# A47 Blofield to North Burlingham Dualling

## **Volume 6 6.8 Masterplan**

Deadline 4

## SCHEDULE OF CHANGES

**MASTERPLAN SHEET 1 OF 7 TR010040/APP/6.8**

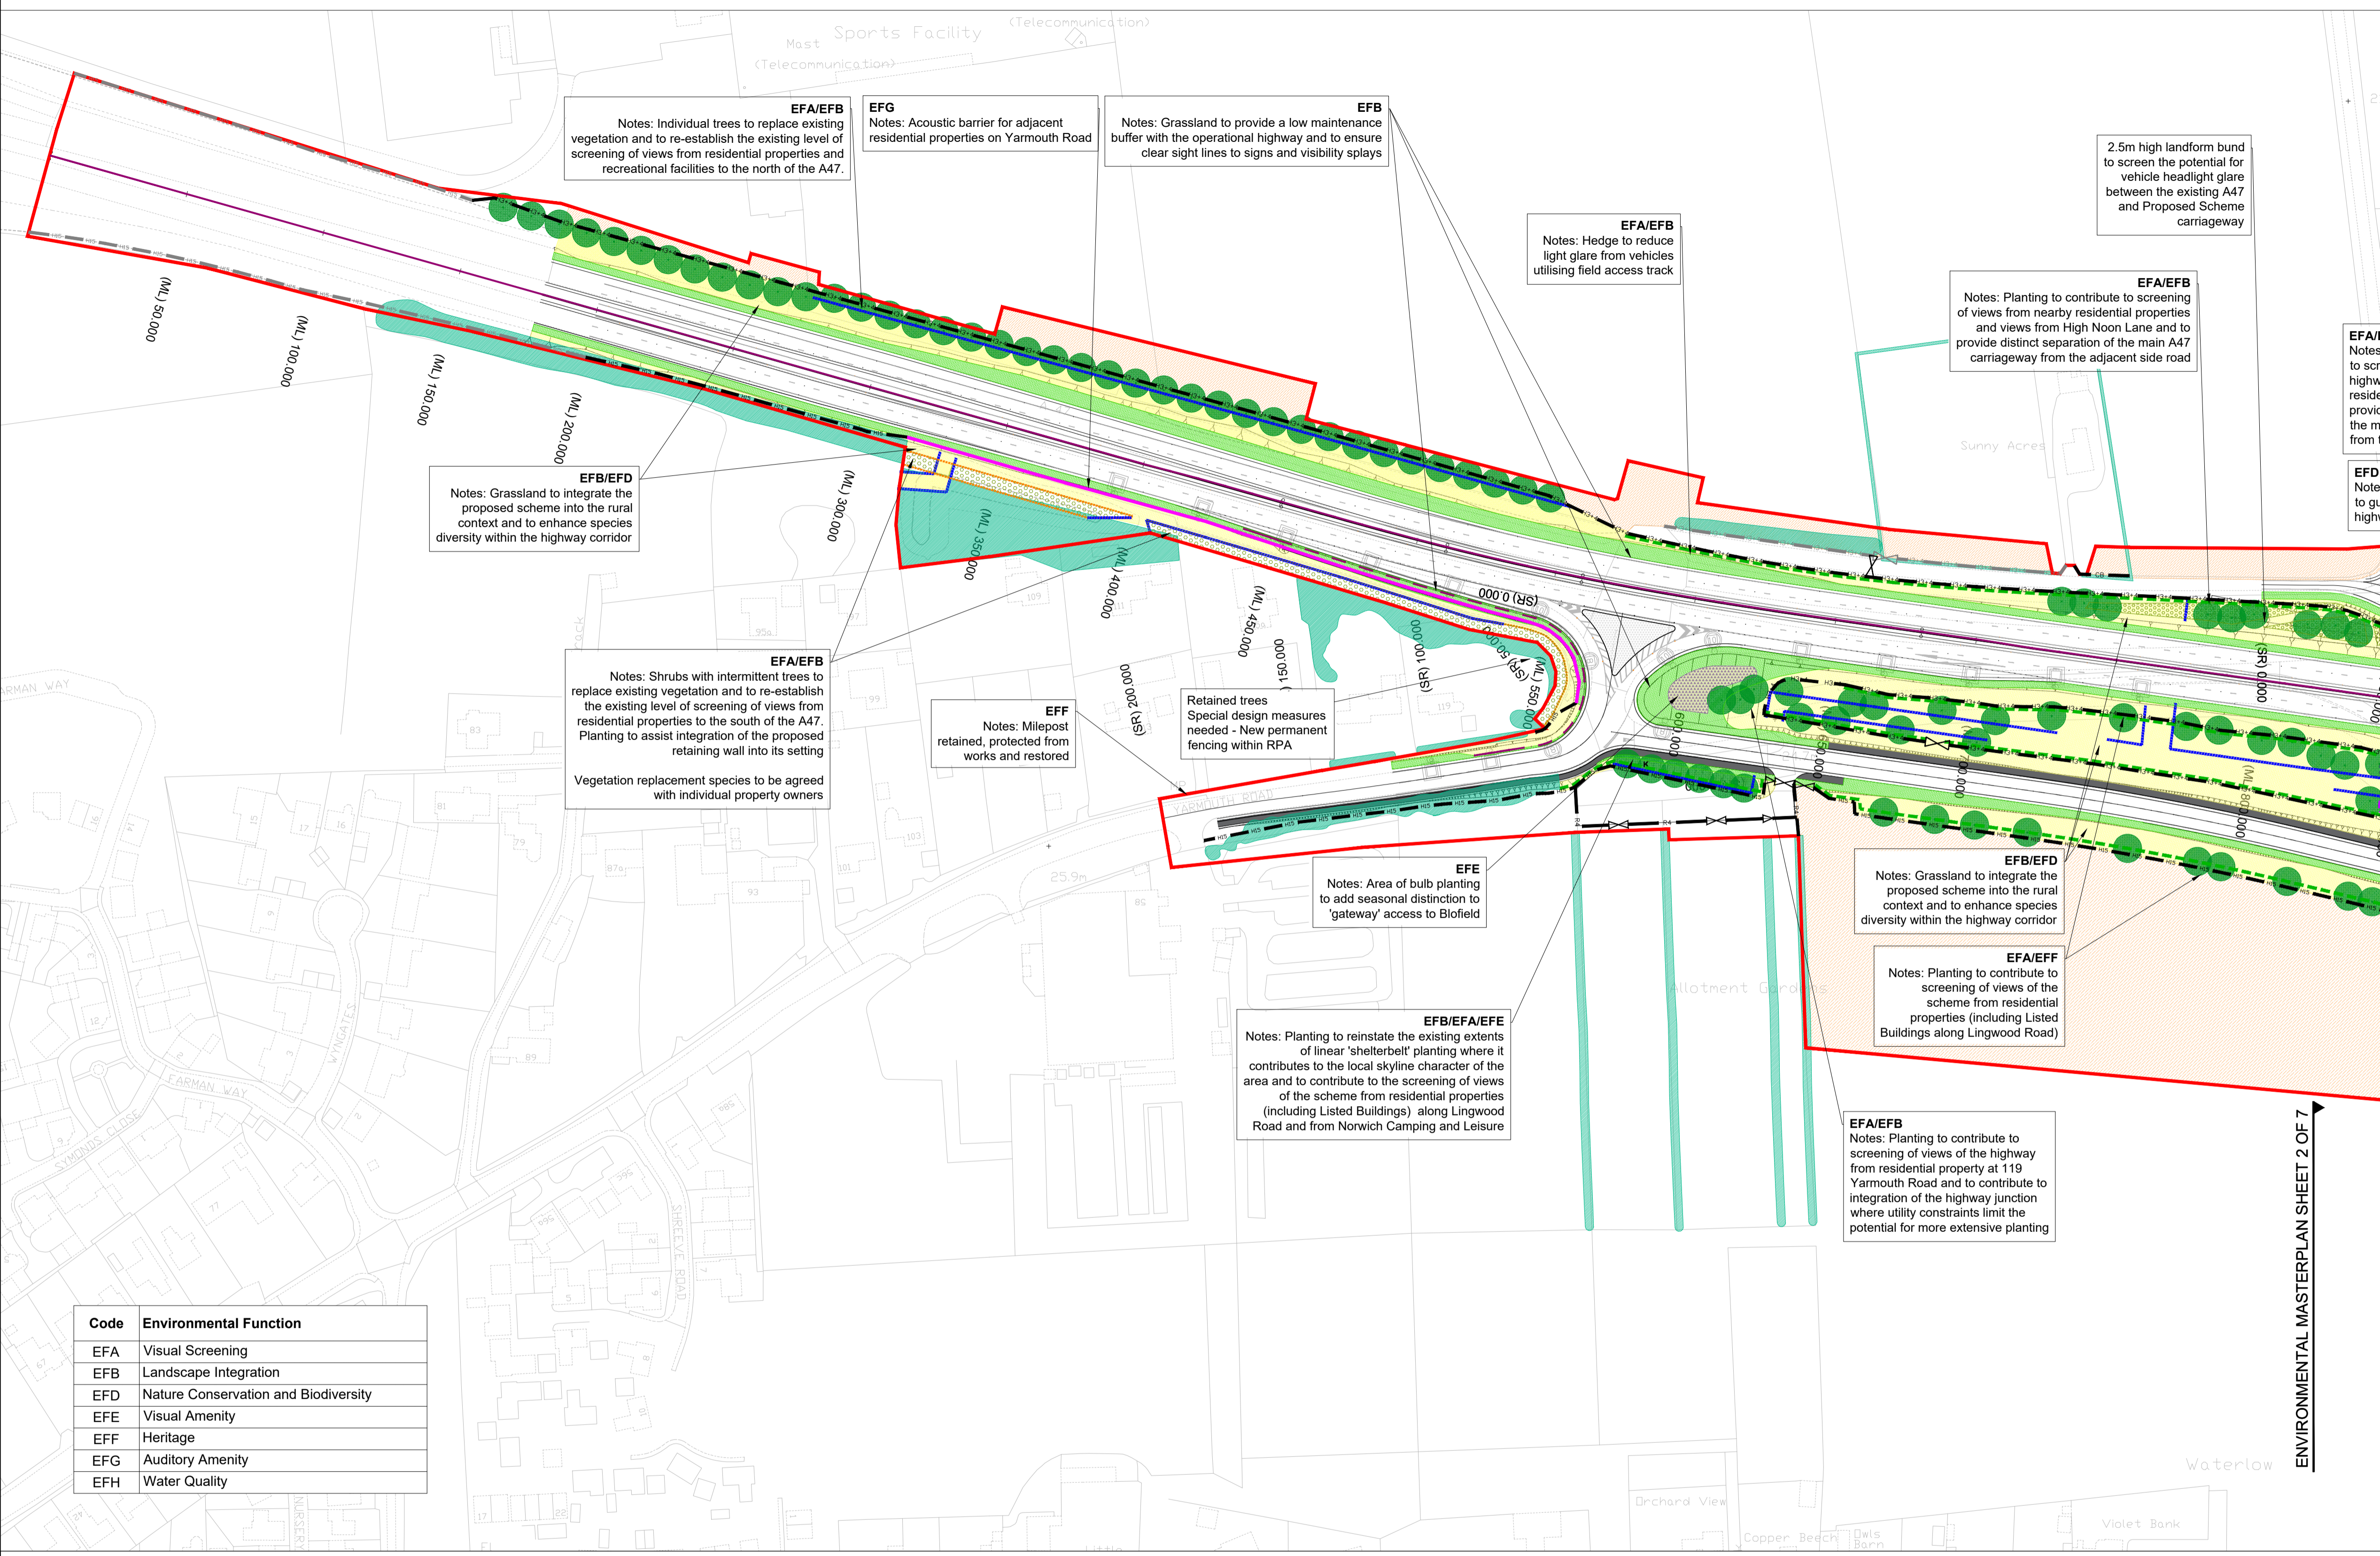
- Fenceline at Blofield Allotments updated to reflect preference of the Allotment Association (Sheet 1).
- Fenceline adjacent to the Agricultural Access Track relocated to reflect the agreement made with Norfolk County Farms.
- Landscaping updated to reflect additional loss of woodland and proposed replacement planting due to the change associated with Cadent Block Valve.
- Plant Schedule mixes updated.

DRAWING TITLE  
**MASTERPLAN SHEET 5 OF 7 TR010040/APP/6.8**

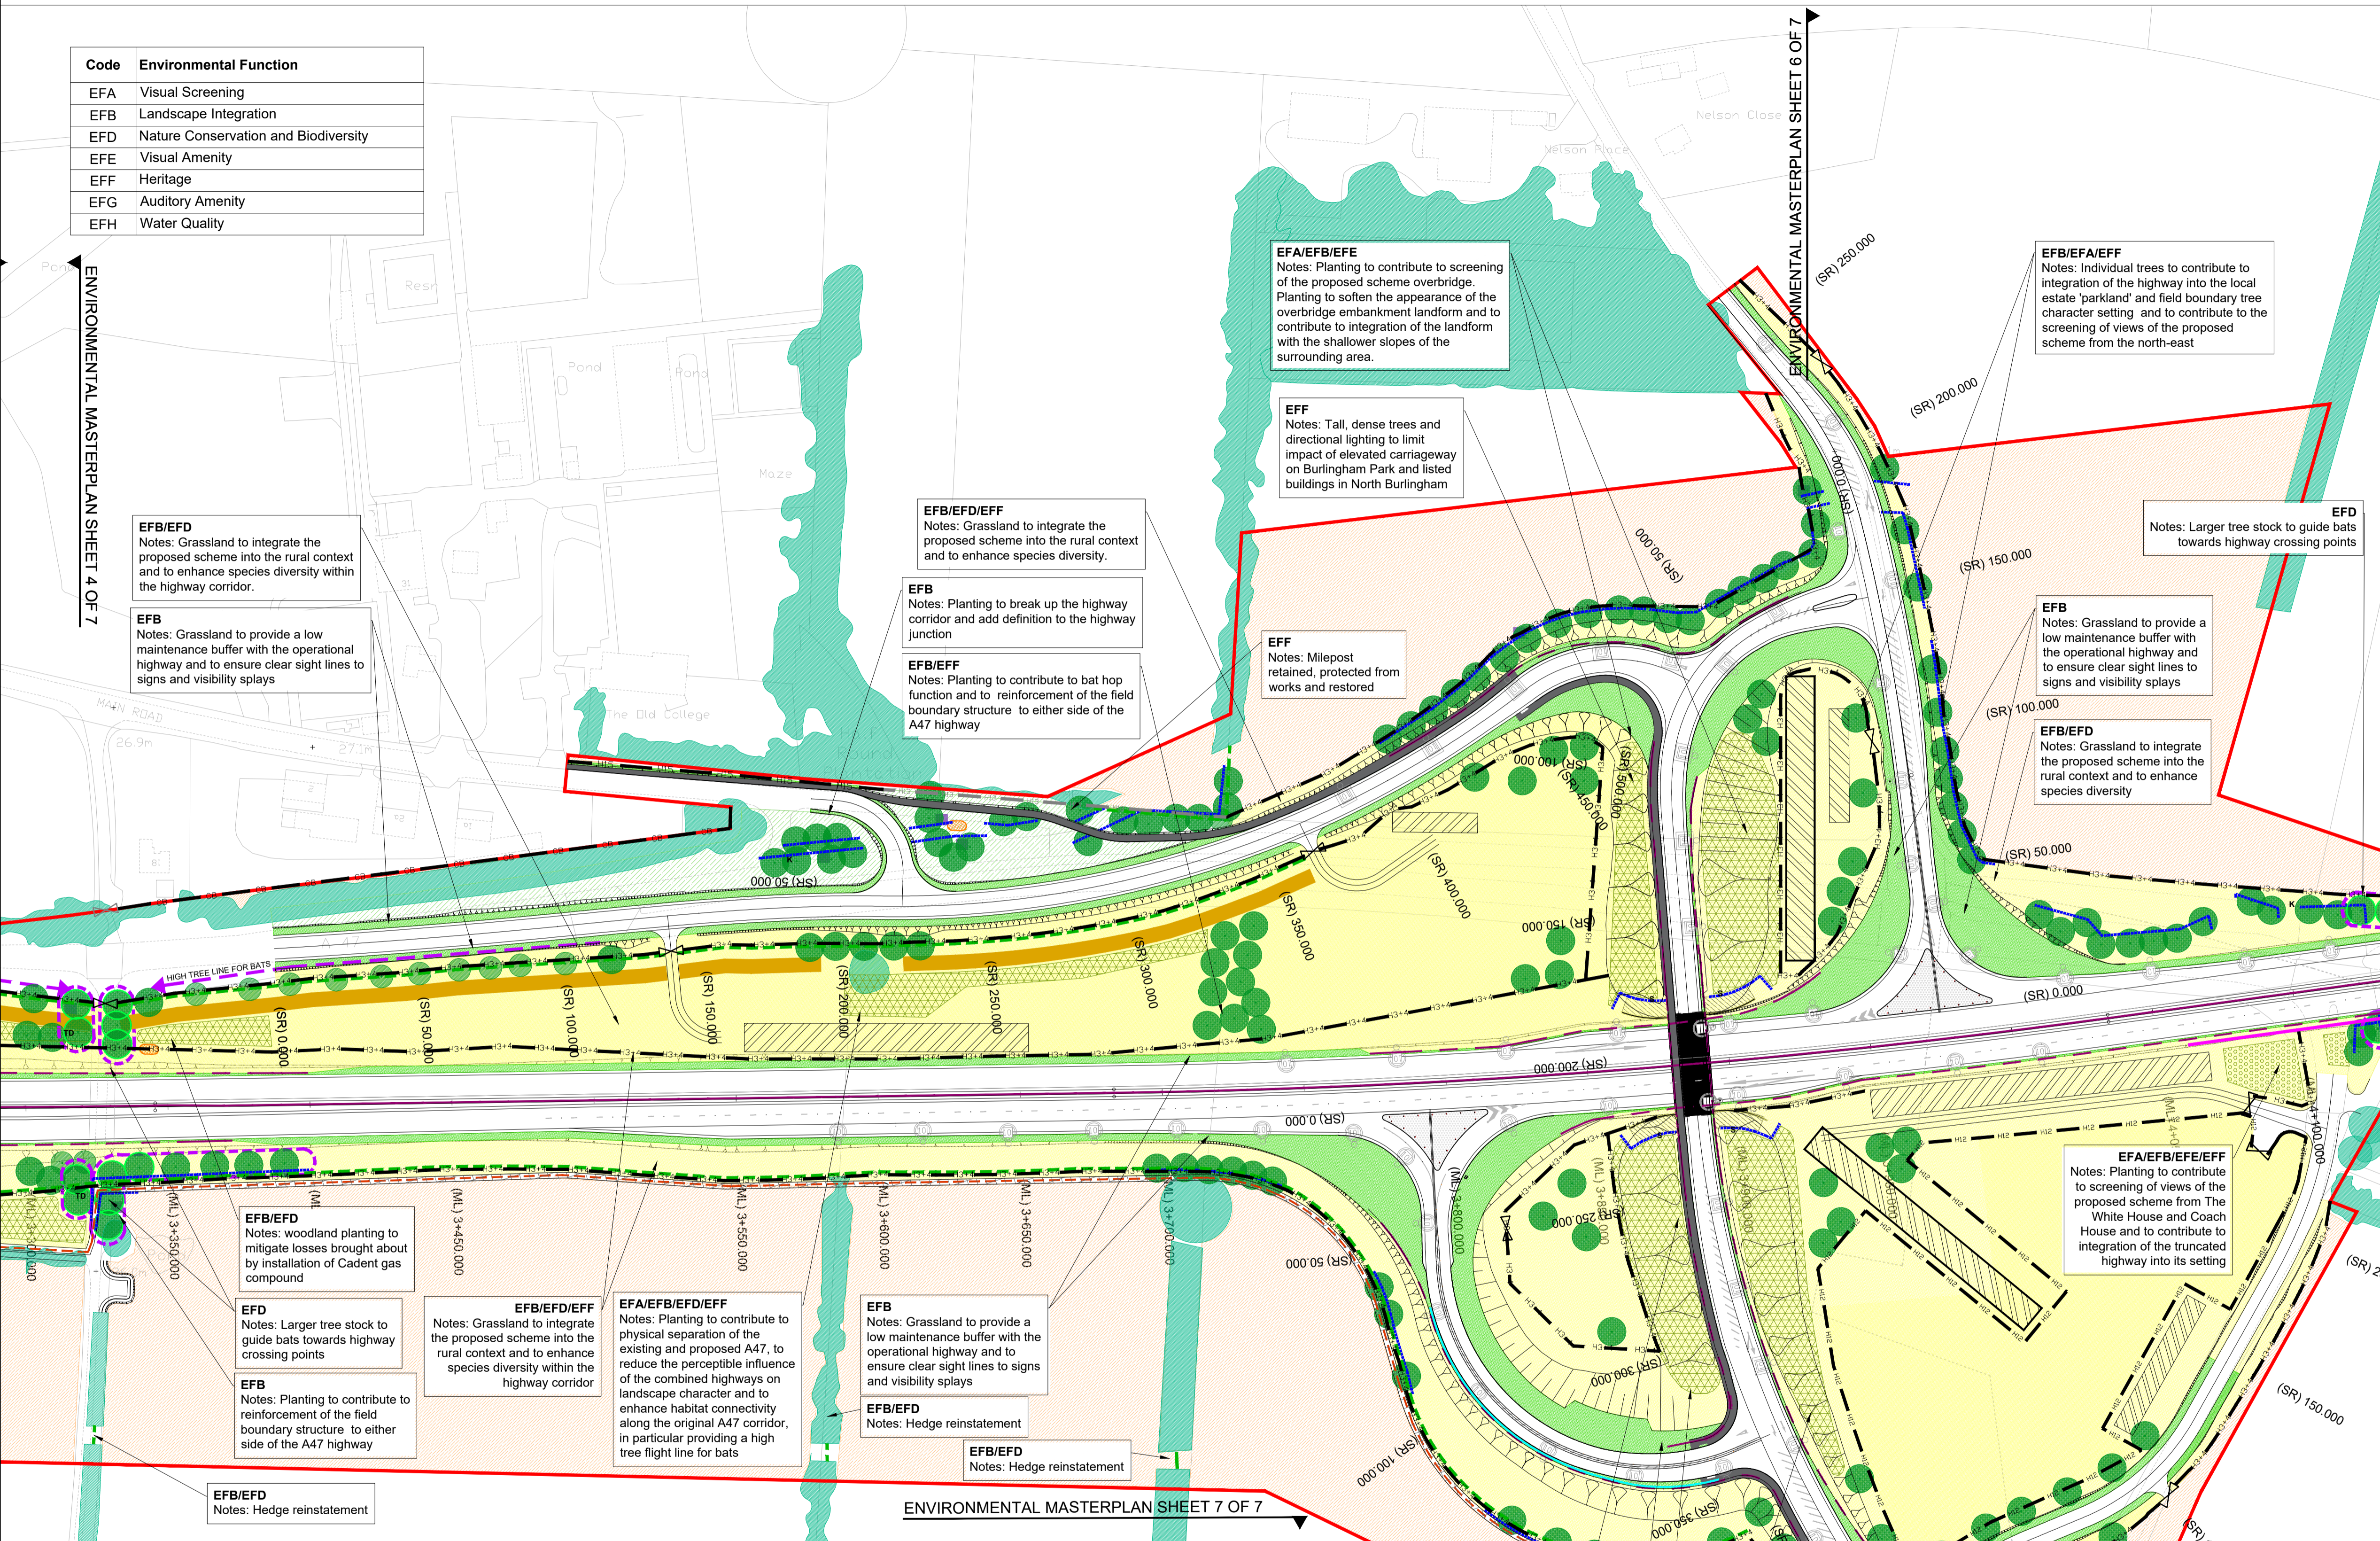
- Planting adjacent to The White House (Sheet 6)
- New Private Means of Access, off existing B1140.
- Fenceline and landscaping adjacent to the Agricultural Access Track updated to reflect agreement with Norfolk County Farms. (Fenceline change omitted in error, updated at Deadline 4)
